GENOA CHARTER TOWNSHIP PLANNING COMMISSION PUBLIC HEARING NOVEMBER 13, 2018 (TUESDAY) 6:30 P.M. AGENDA

Attention:	Kelly Van Marter, AICP	
	Planning Director and Assistant Township Manager	
Subject:	Dog Town/Kitty City – Special Land Use and Site Plan Review #3	
Location:	3557 East Grand River Avenue – north side of Grand River, east of intersection with	
	Grand Oaks Drive	
Zoning:	GCD General Commercial District

At the Township's request, we have reviewed the revised submittal for Dog Town/Kitty City, including the special land use application (dated 7/31/18) and revised site plan (most recently dated 9/19/18).

SPECIAL LAND USE: WETLAND SETBACK

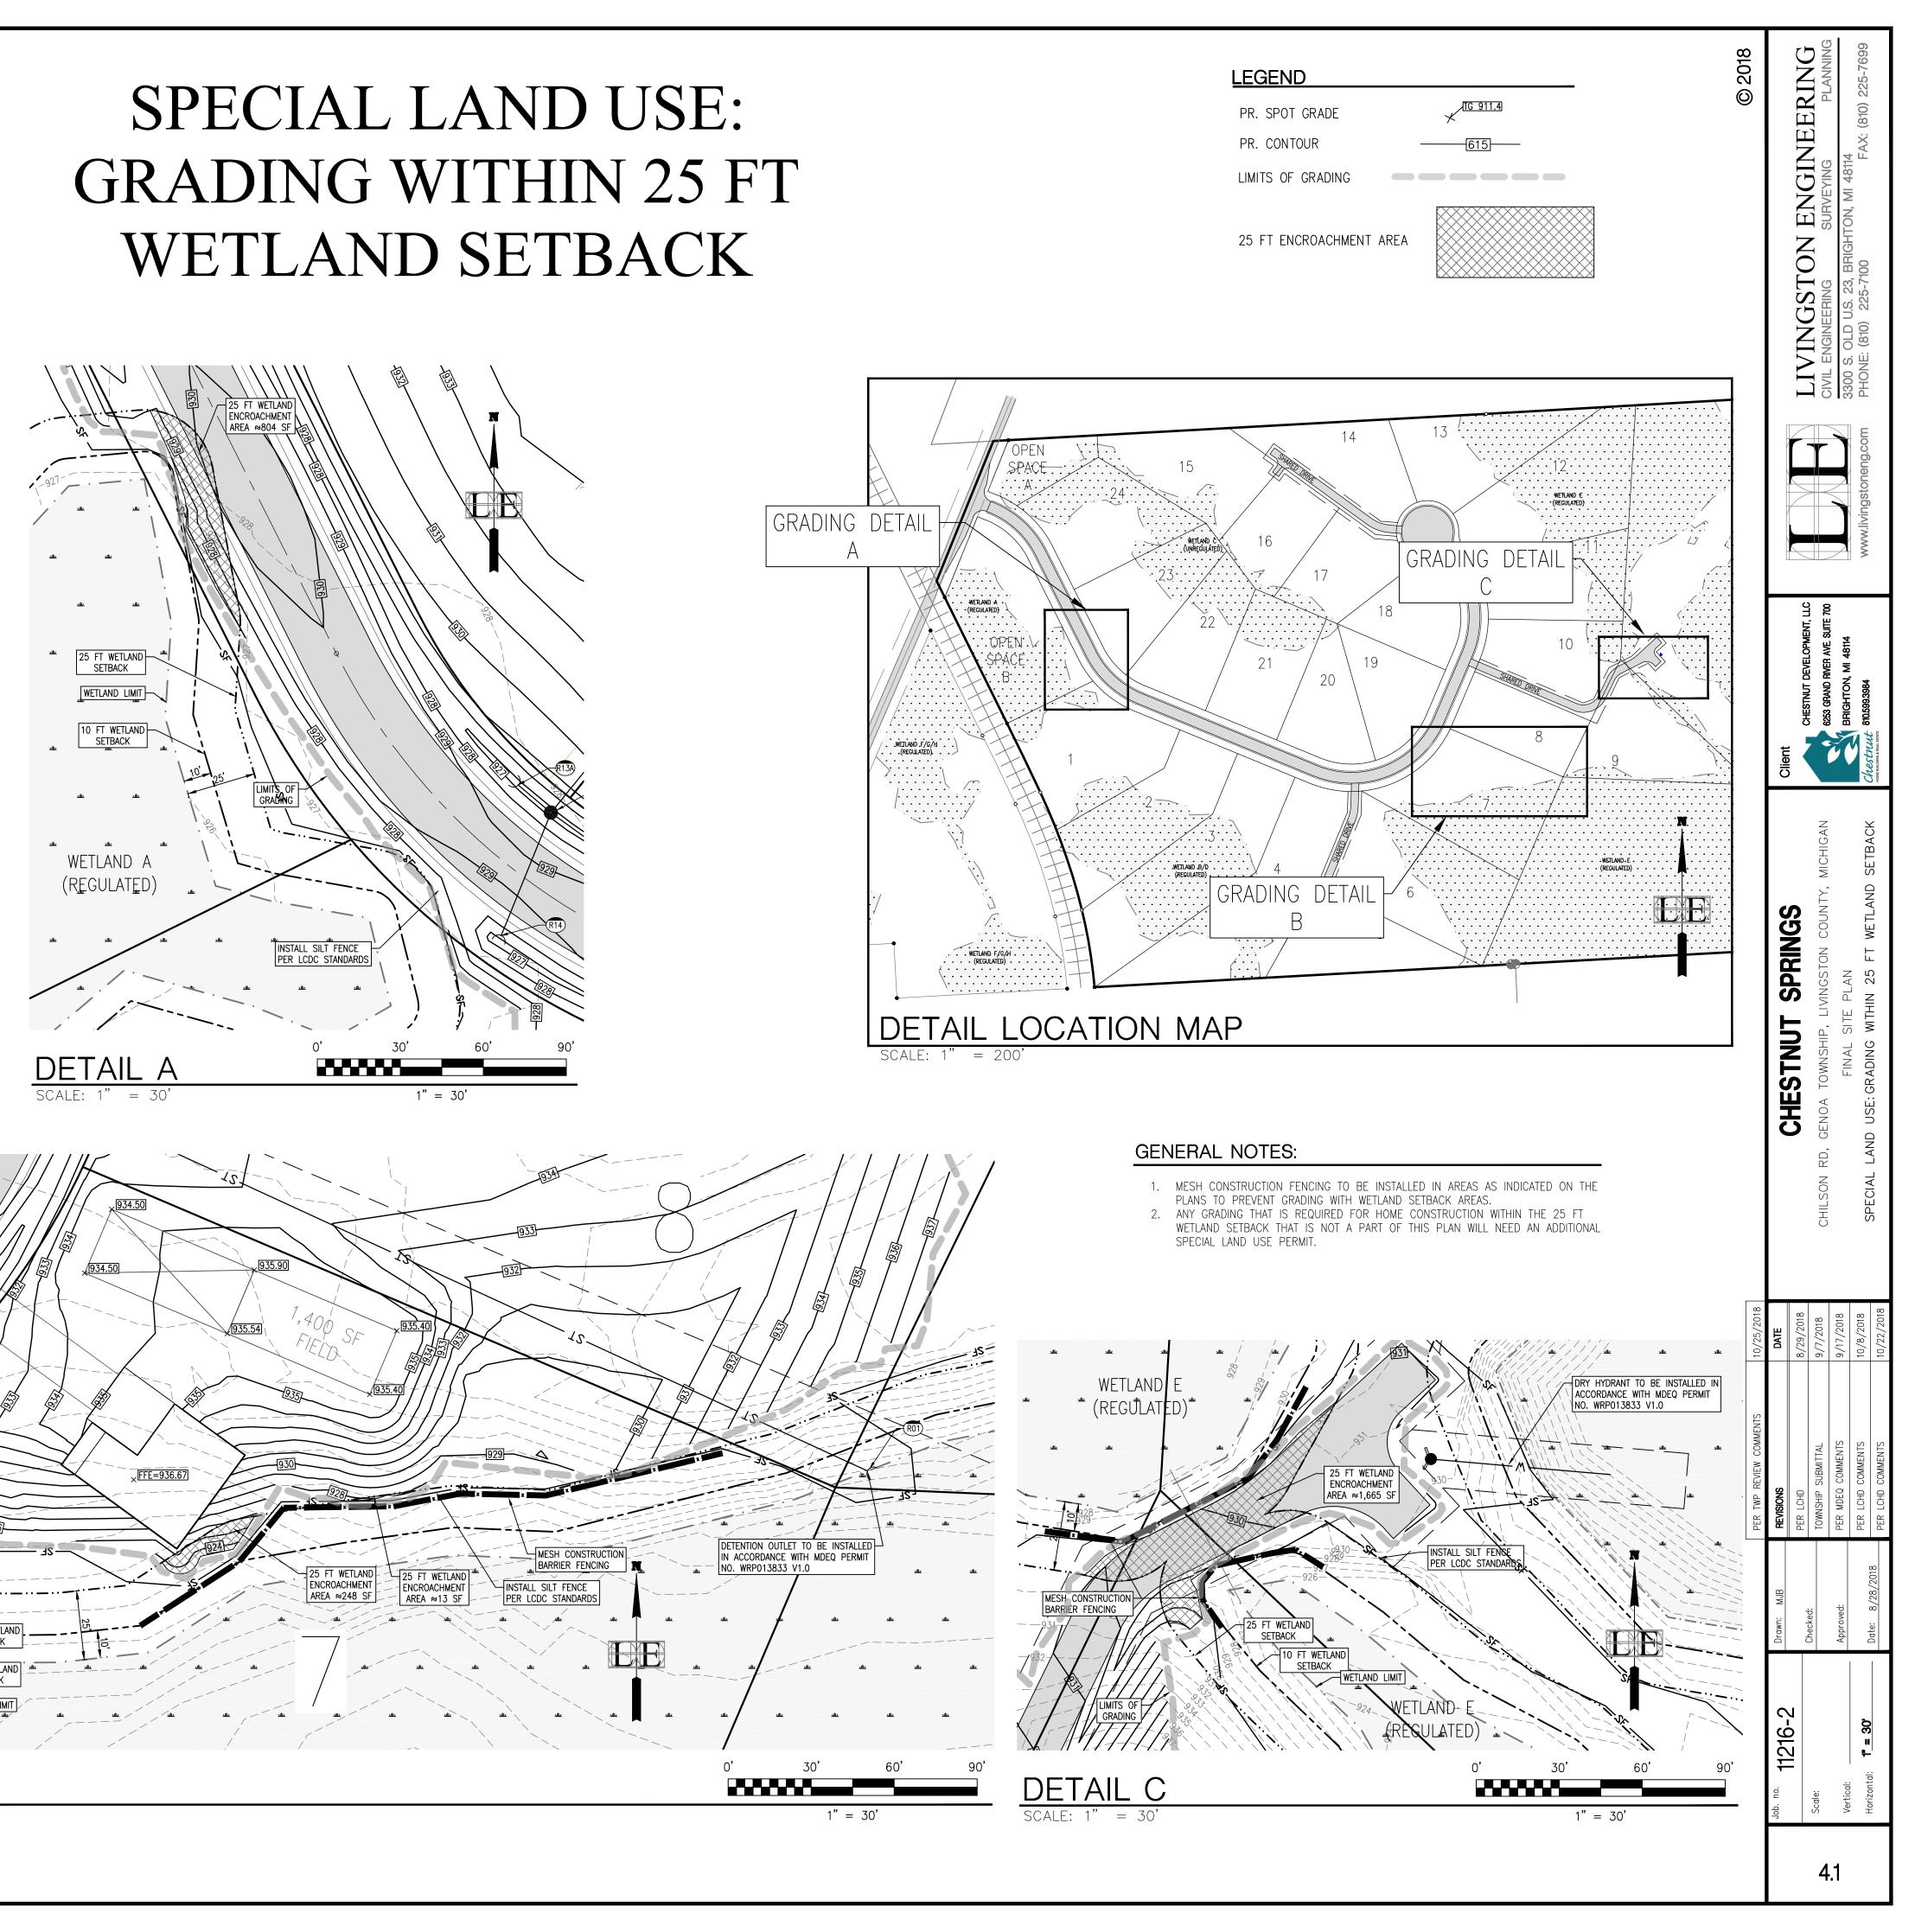
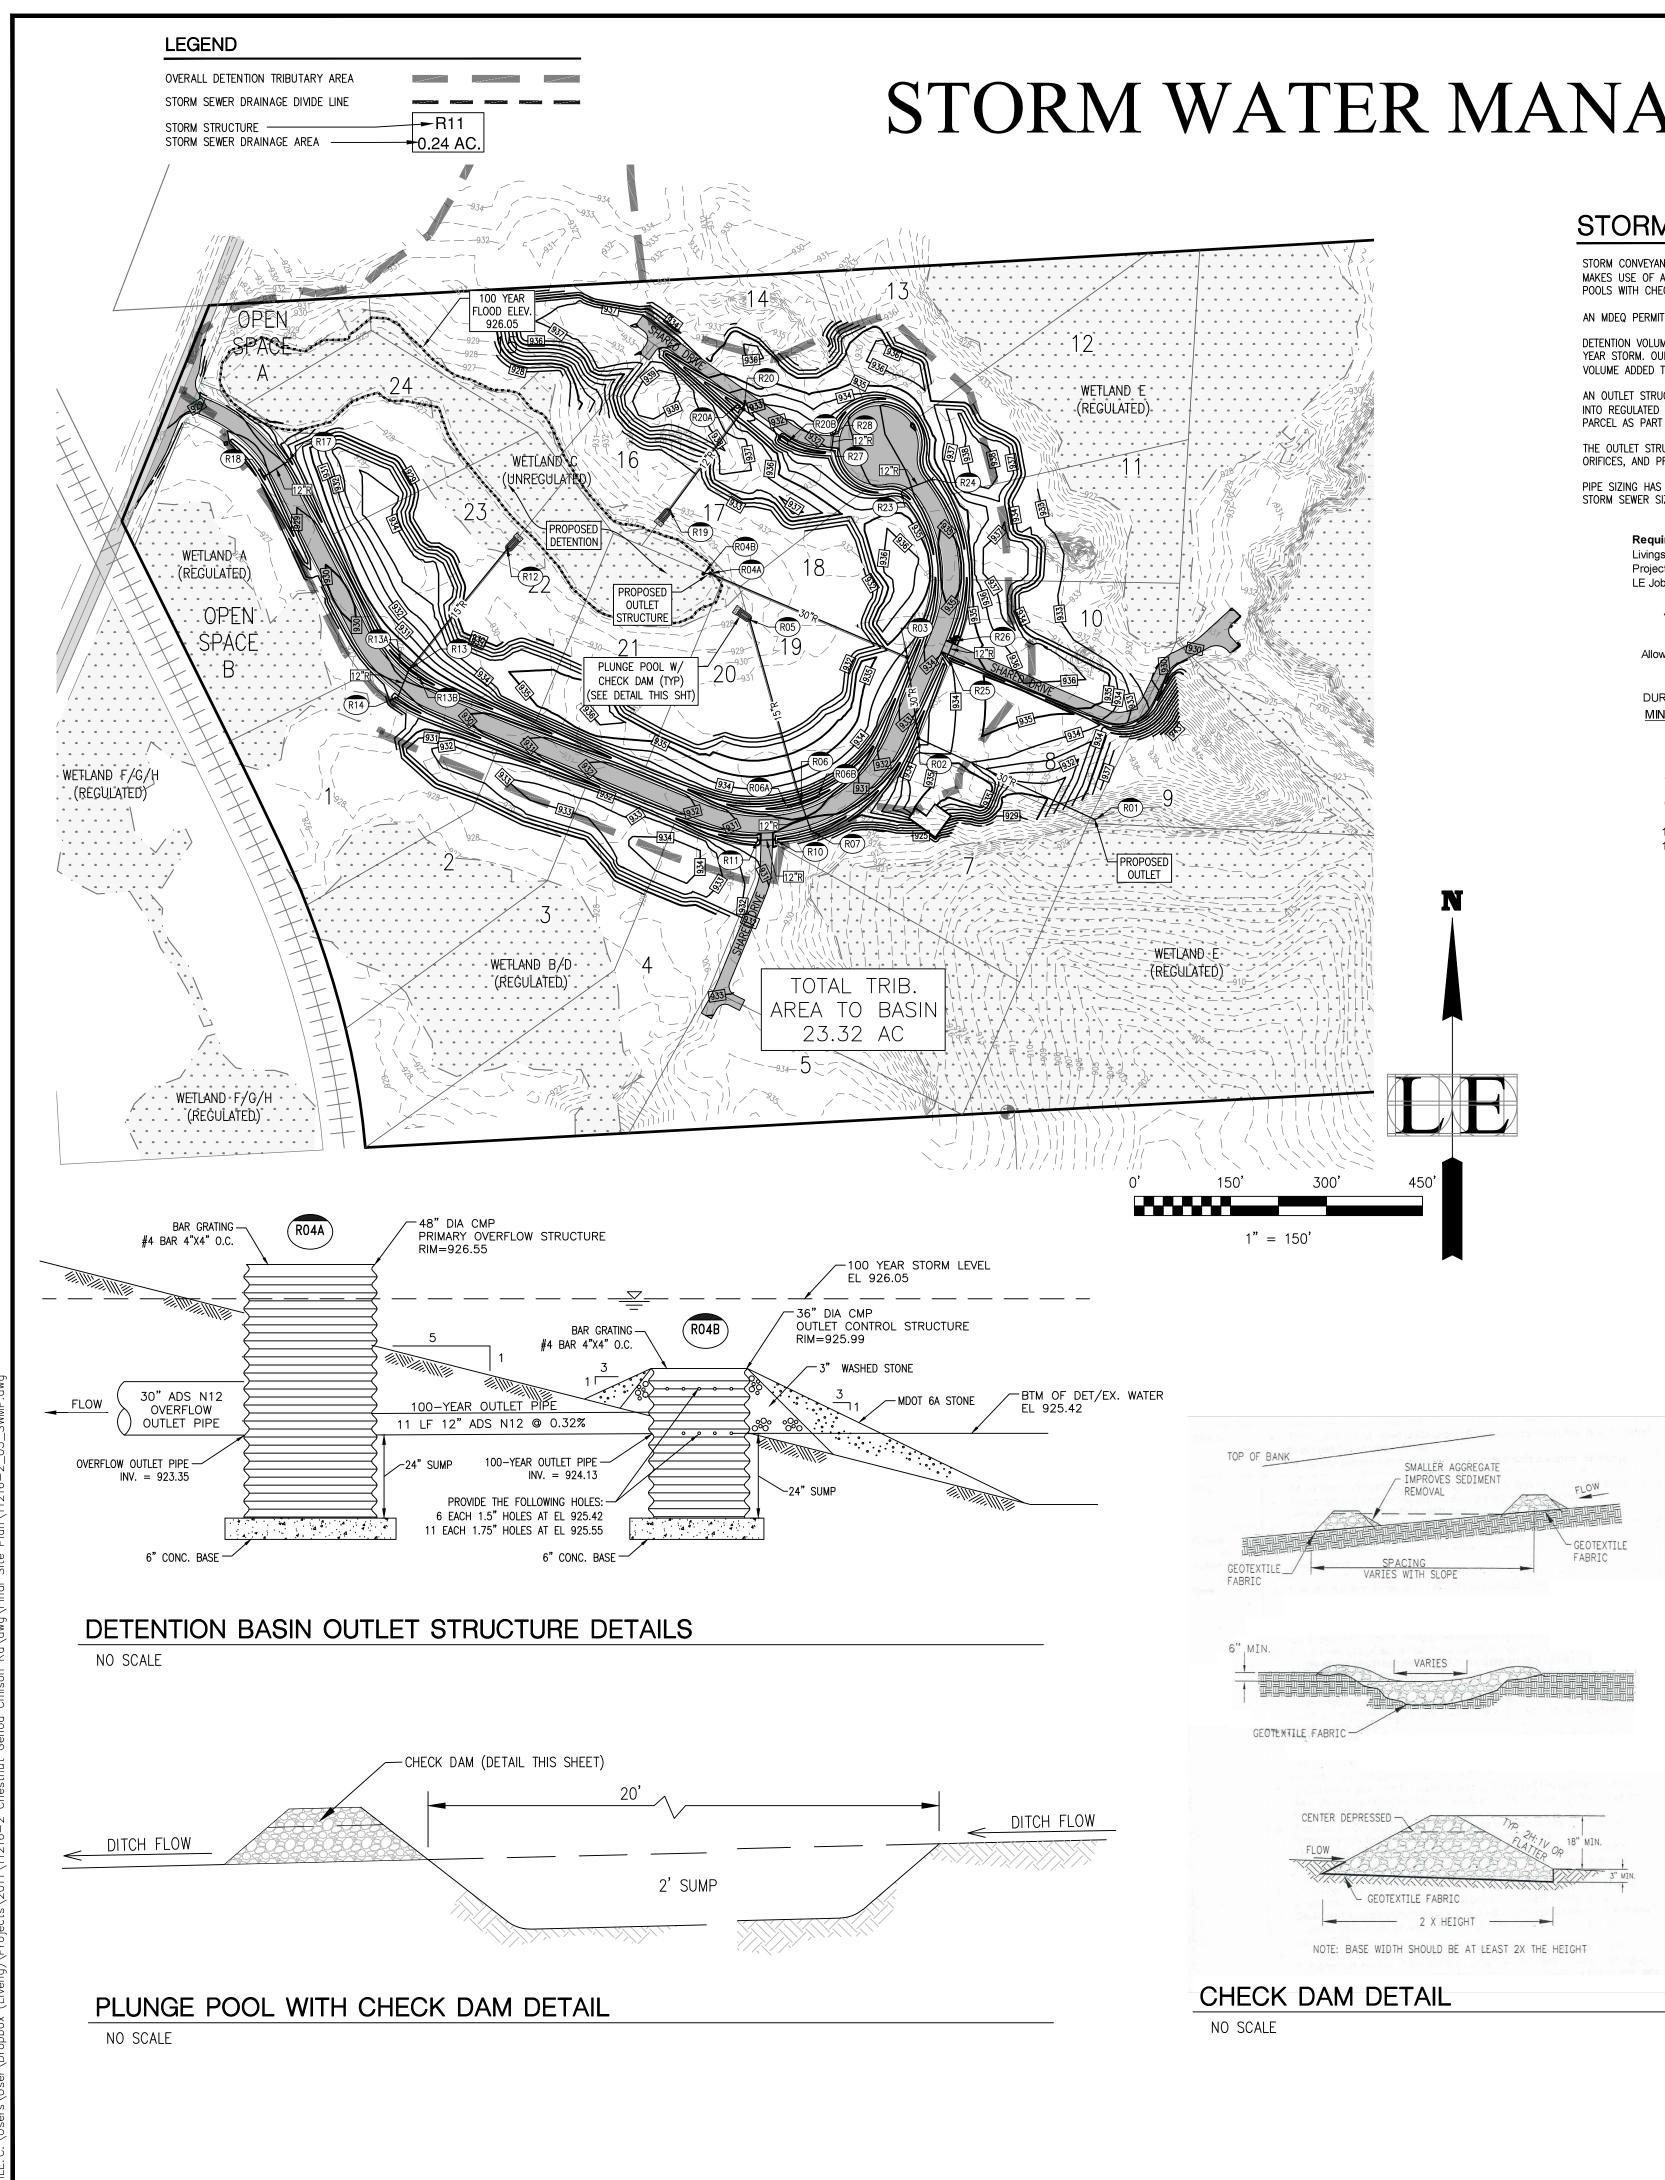
- **3.** Natural Feature Setback. Section 13.02.04 requires a 25-foot setback from the edge of a regulated wetland. The final plan highlights four areas of encroachment, detailed on Sheet 4.1, as follows:
 - a. Detail A: the roadway just west of Open Space B
 - b. Detail B: an area directly behind the proposed house on Unit 7
 - c. Detail B: an area between the proposed house and septic field on Unit 7
 - d. Detail C: the shared driveway access for Units 9 and 25

Based on Sheet 4.1, the road, drive and grading for Unit 7 encroachments are not into the wetlands themselves, nor are they within 10 feet of the wetlands at their nearest point. The detention outlet and the dry hydrant connect into the wetlands and were approved by MDEQ.

Details on Sheet 4.1 indicate that a total of 2,730 square feet within the natural feature setback area will be disturbed. In our opinion, this is relatively minor in relation to the total amount of protected and undisturbed land. For comparison, these two wetland areas comprise approximately 15 acres of land on-site.
